IMPORTANT: REIGNITOR REPLACEMENT INFORMATION

**REFRIGERATOR
BULLETIN R68/3A
JUNE 1993**

RE: CHANNEL PRODUCTS MARK 6, MODEL 12E REIGNITOR

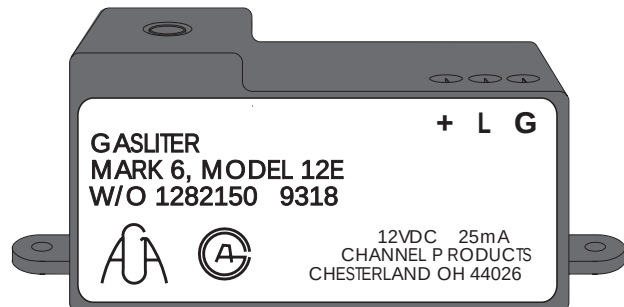
DO NOT install the Channel Mark 6, Model 12E Reignitor (shown above) as a service replacement part on the following:

Installing the Channel Mark 6, Model 12E, rated 25 MA, on those models previously listed can result in failure to ignite on gas if the DC power supply is below 12.5 volts DC. The reignitor will see low voltage and not produce a spark, resulting in flame failure lock-out.

Installation of the Channel Products, Inc. Gasliter Mark 6, Model 12E, will **VOID** the Warranty on the previously listed models. All other refrigerator models not listed in this Bulletin can continue to use the 7679100003 Reignitor. Substitution of 2931132019 for 7679100003 is acceptable.

The reignitor installed on the above refrigerators as original equipment is part number 2931132019 (RV Gas Model 679). This reignitor is rated 50 MA and **must** be used on all models listed above. This reignitor may also be used on any other model.

Please inspect your reignitor parts inventory under part number 2931132019 and purge all reignitors not rated 50 MA into a separate inventory located under part number 7679100003.
